EDGE-ON-HUDSON

APPLICATION FOR SITE PLAN & SUBDIVISION APPROVAL

PHASE ONE SUPPLEMENTAL SUBMISSION

Re: Phase 1 Site Plan and Subdivision Application
Edge-On-Hudson Riverfront Development
199 Beekman Avenue, Sleepy Hollow

DRAWING NO. LP-1
(SHEET 2 OF 5)

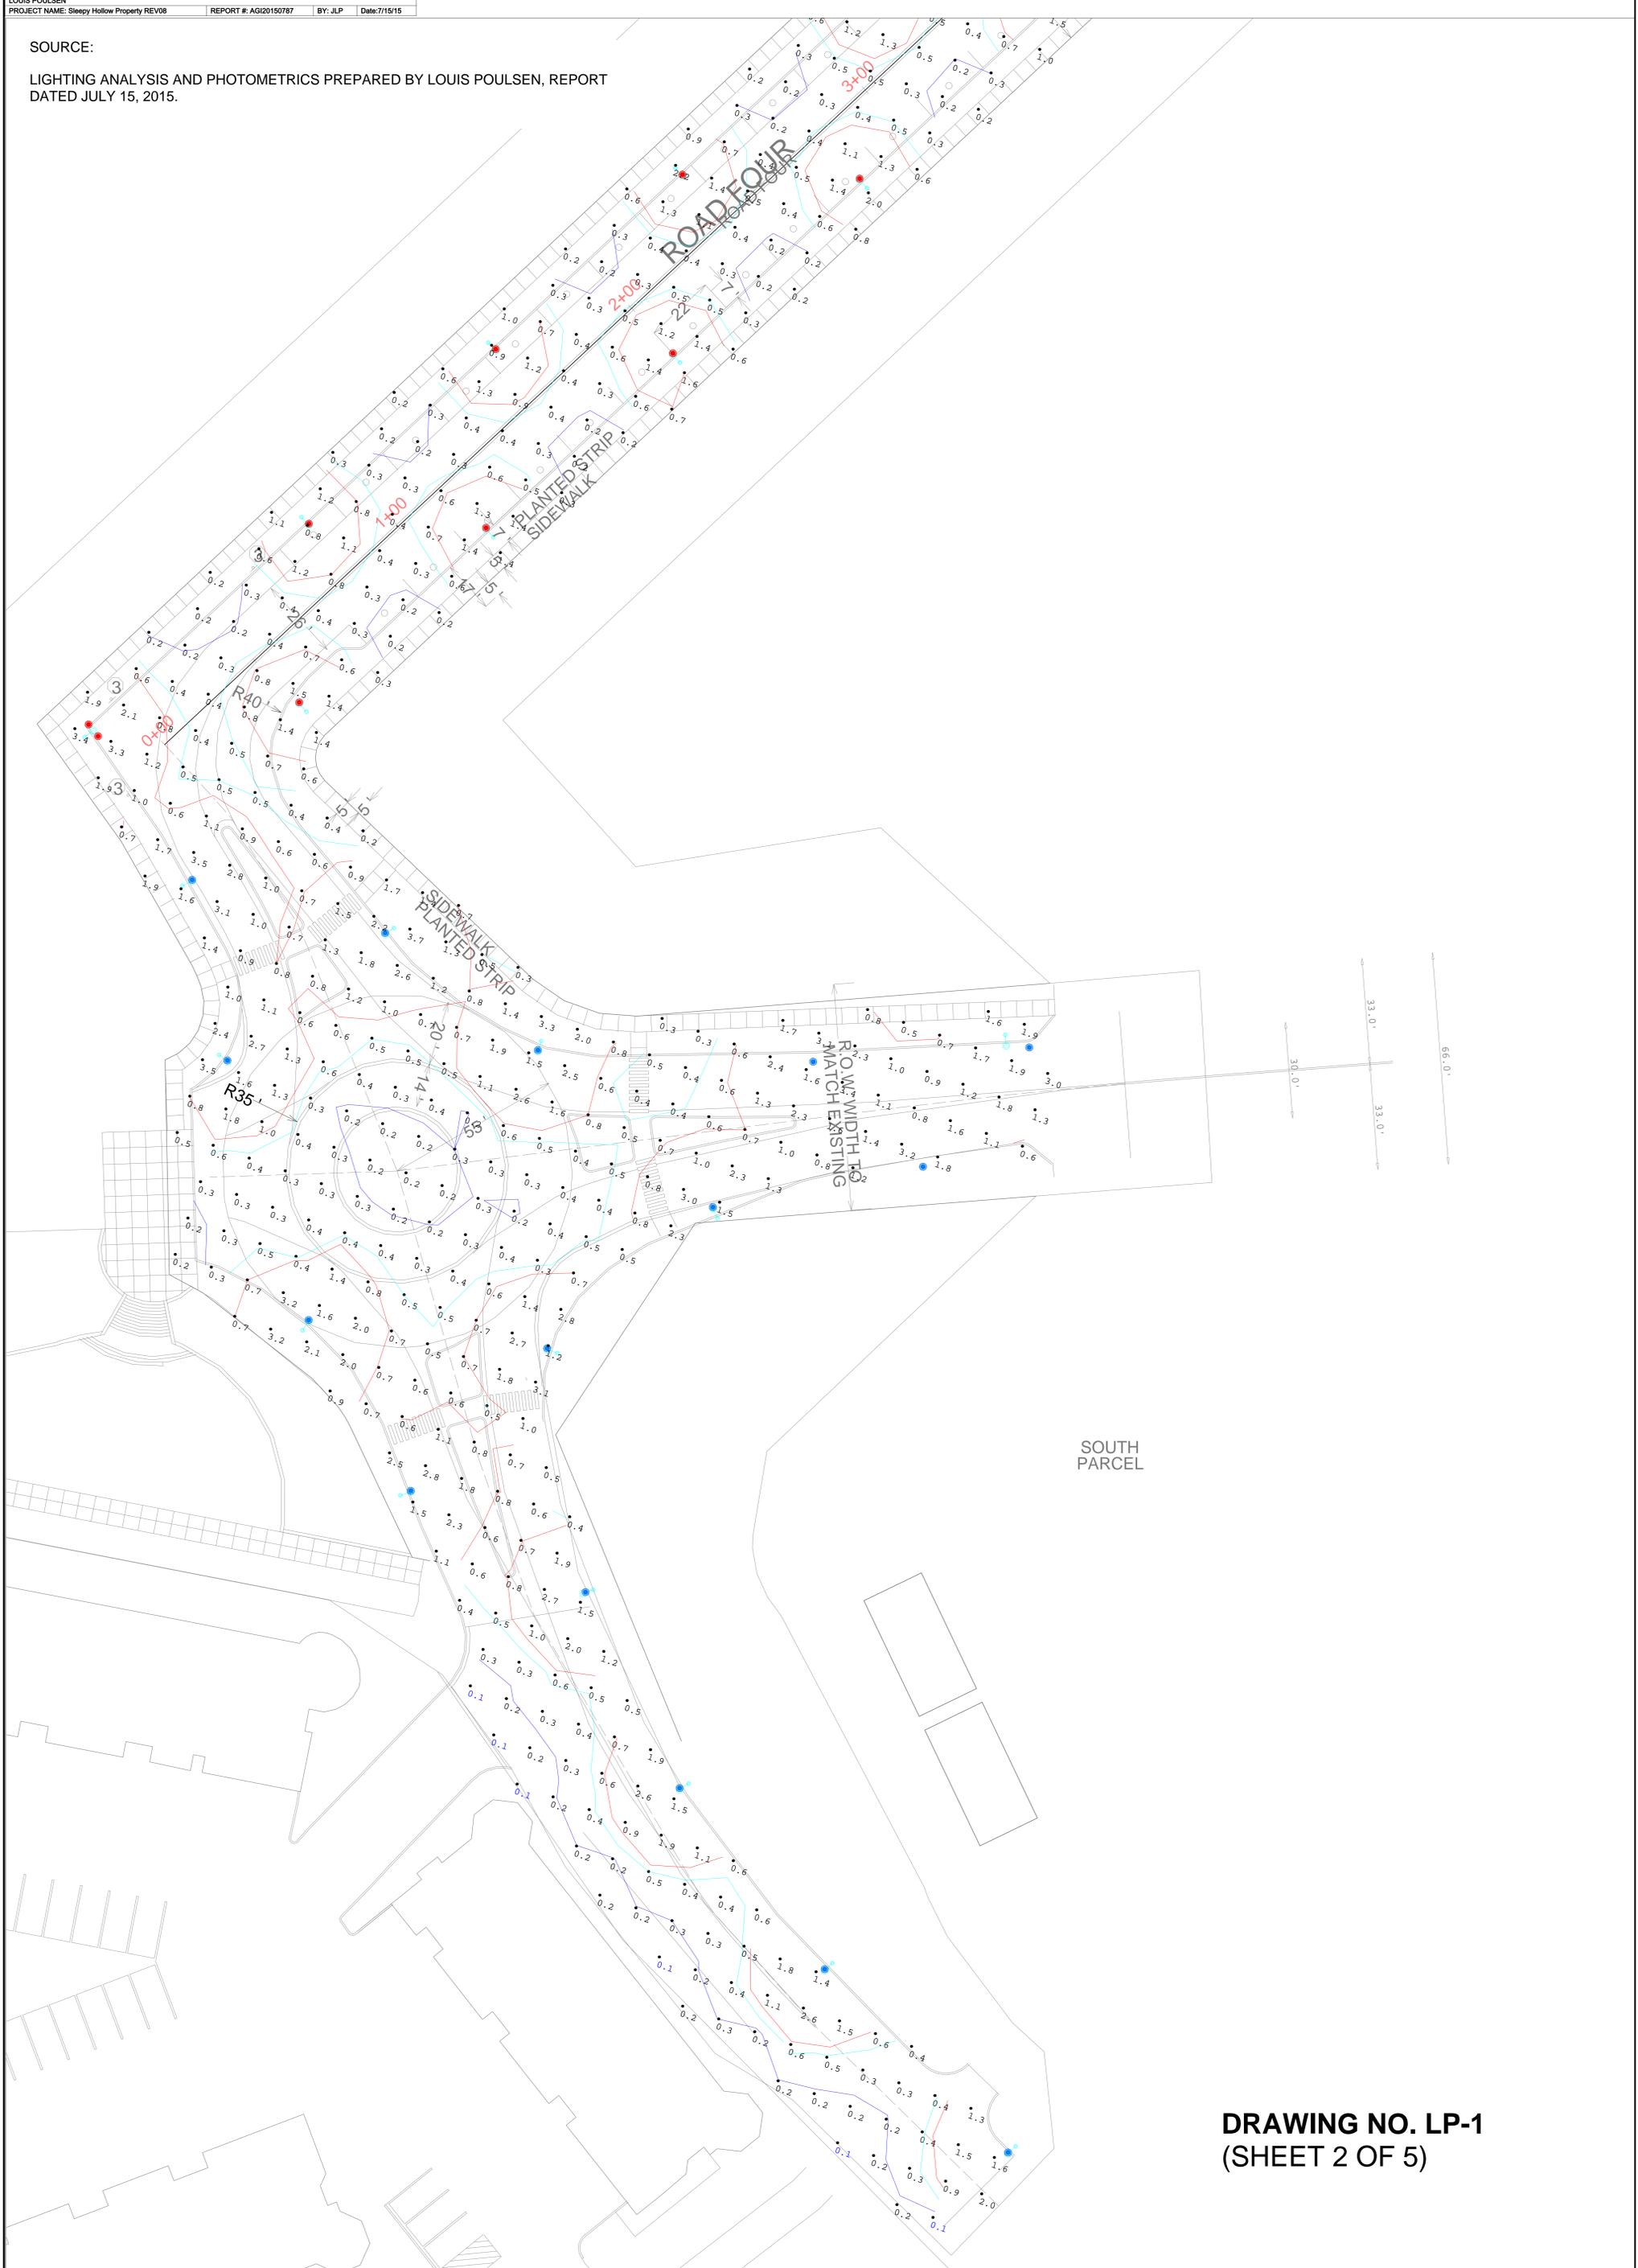
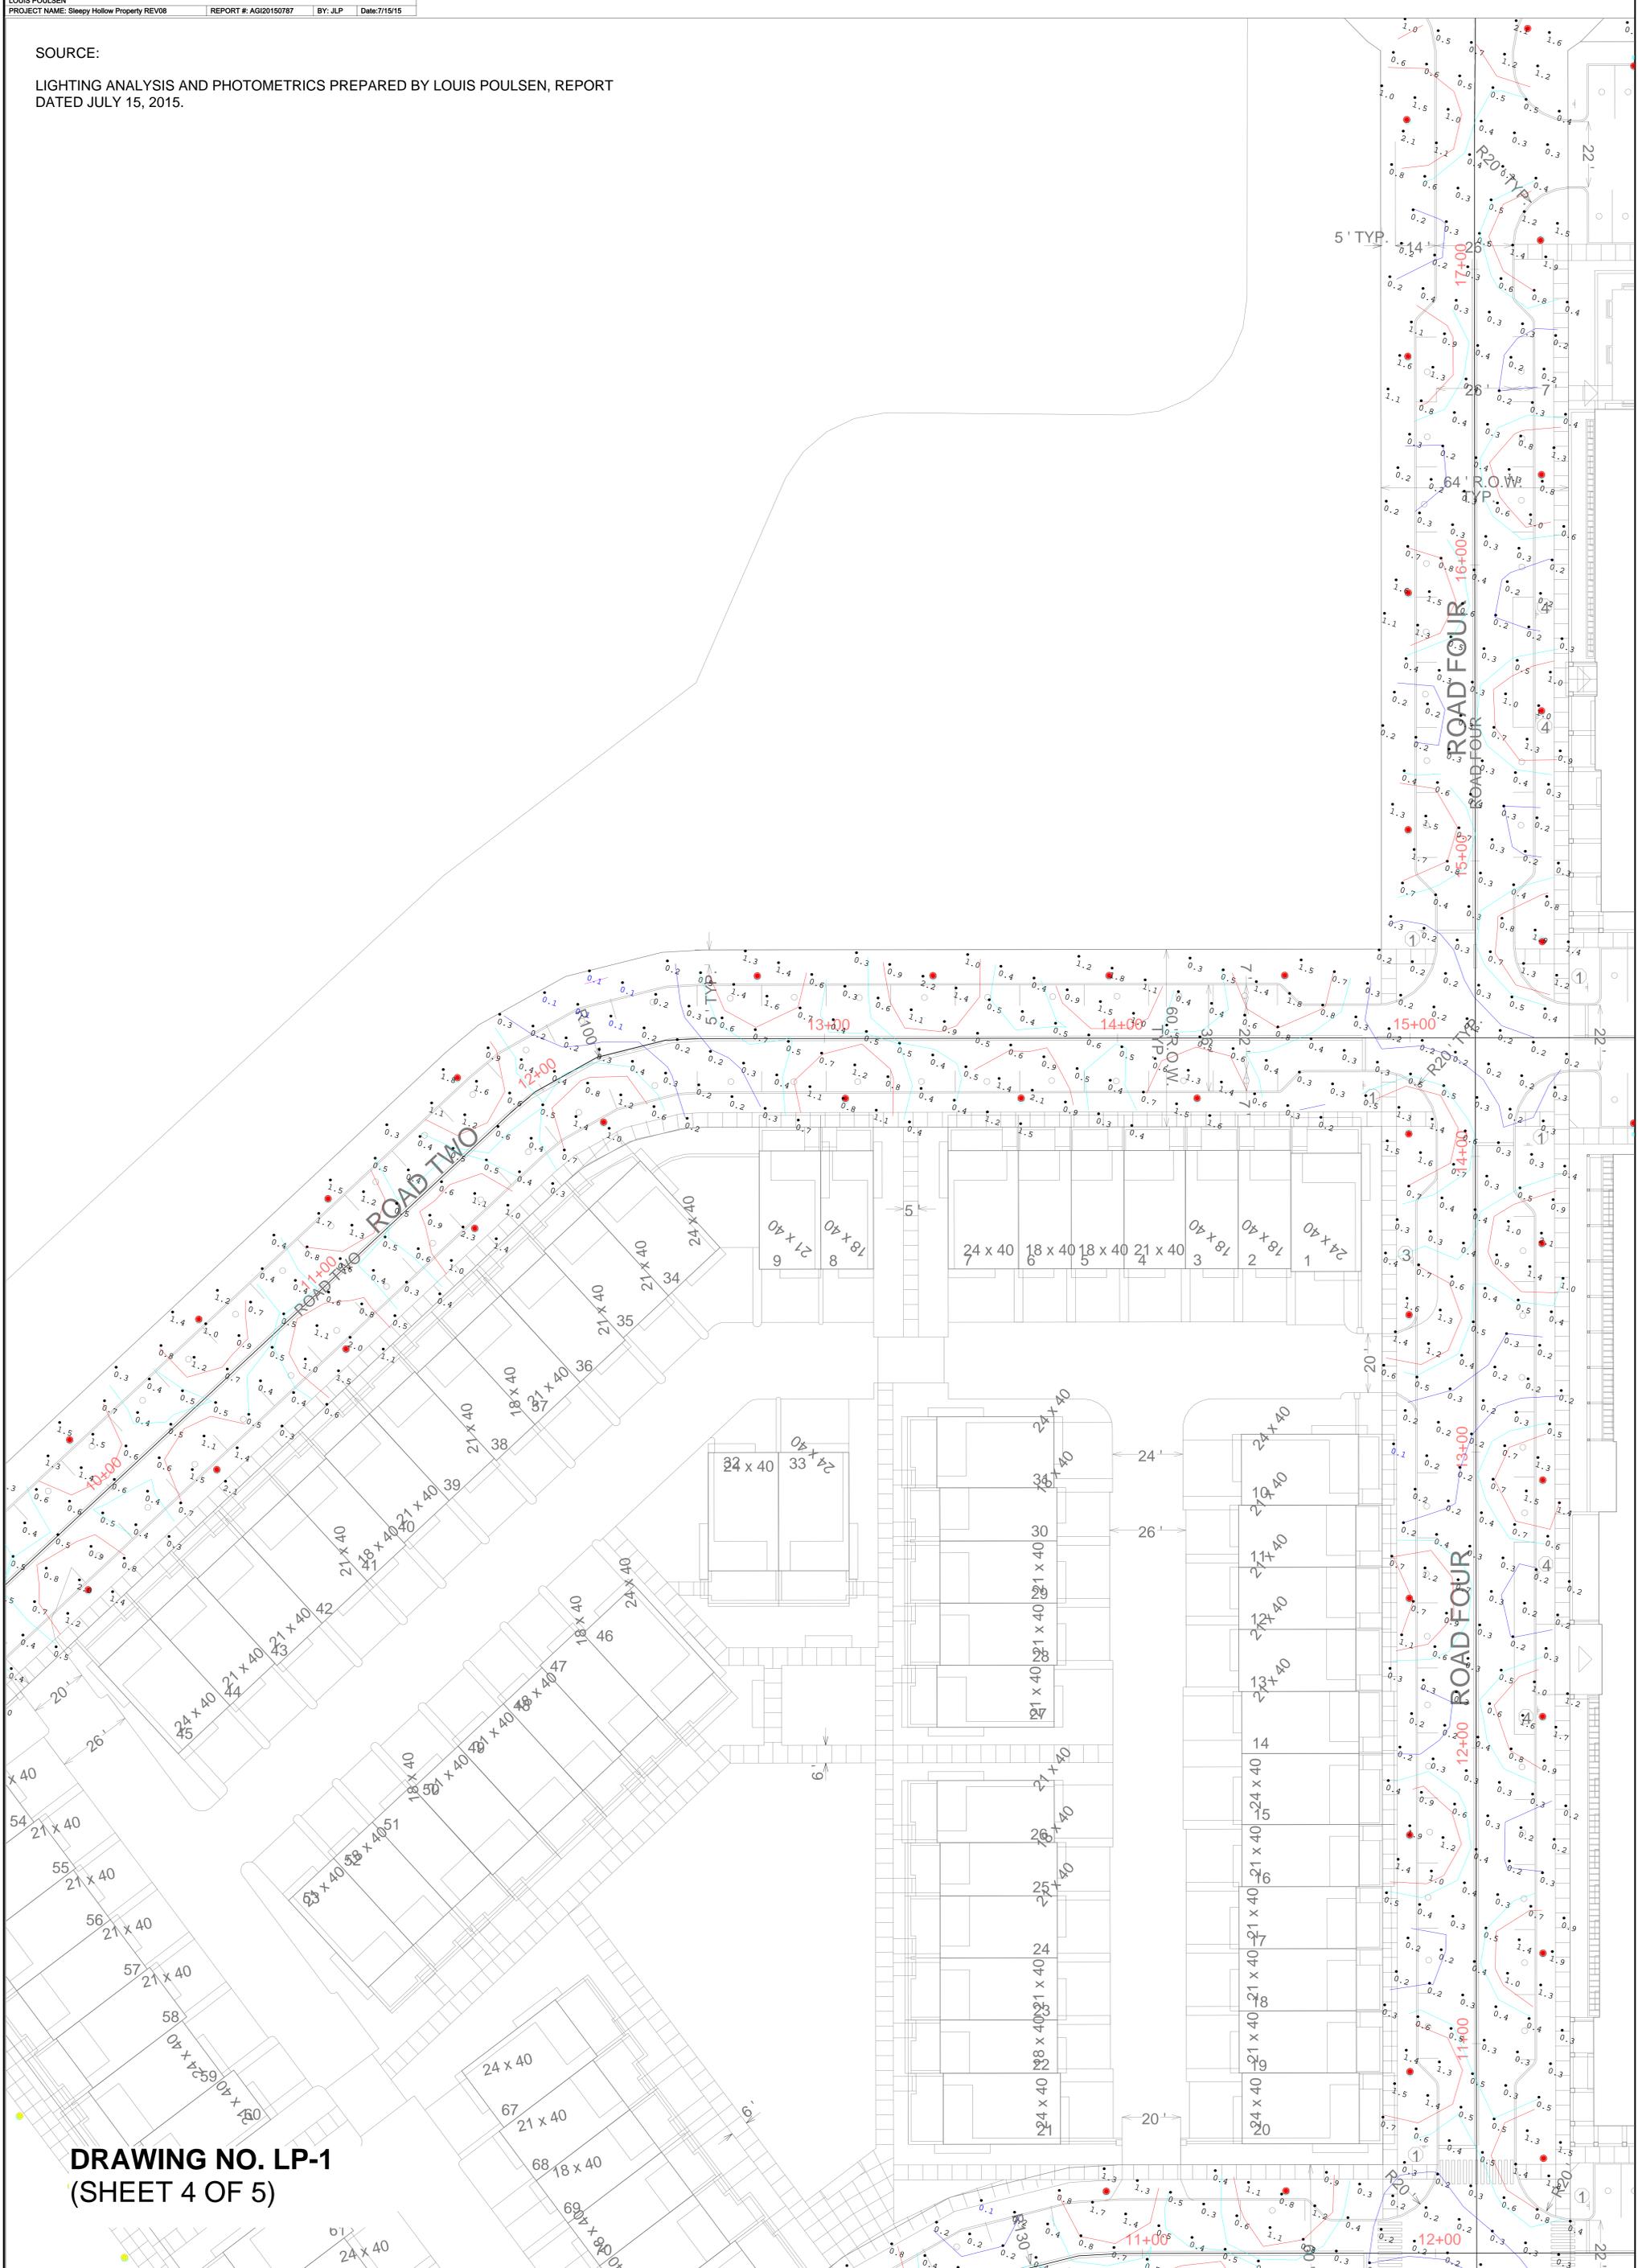
- G3. **Comment:** *A photometric plan must be submitted for review.*
- Response:** A photometric plan is included with this submission set and is appended to the engineering set of plans; see Sheets LP-1 through LP-4. The proposed street, pedestrian and bollard light fixtures are shown on page 9 of the attached Landscape Architecture Exhibit. The Edge-On-Hudson lighting concept is to utilize fixtures that reflect the regional character of the Hudson River Valley, complement the site furniture and knit together each district and the public realm. The uniformity in street lighting and pedestrian lighting will contribute to the sense of a pedestrian friendly network in addition to providing a

Street lighting (14' pole mounted) fixtures are located within the public rights-of-way. The sequence begins with metal-halide street light fixtures at the Beekman Avenue roundabout to provide a higher lighting level at that intersection and then transitions to LED fixtures within the Edge-On Hudson site. Pedestrian lighting consists of 12' pole mounted fixtures located along the Central Park sidewalk, within Block E and at the neighborhood open space area of Block J, as well as bollard lighting fixtures located along the mews and within entry courtyards. Internal residential access ways will also be lit by wall mounted fixtures located on garages within Blocks J and E.
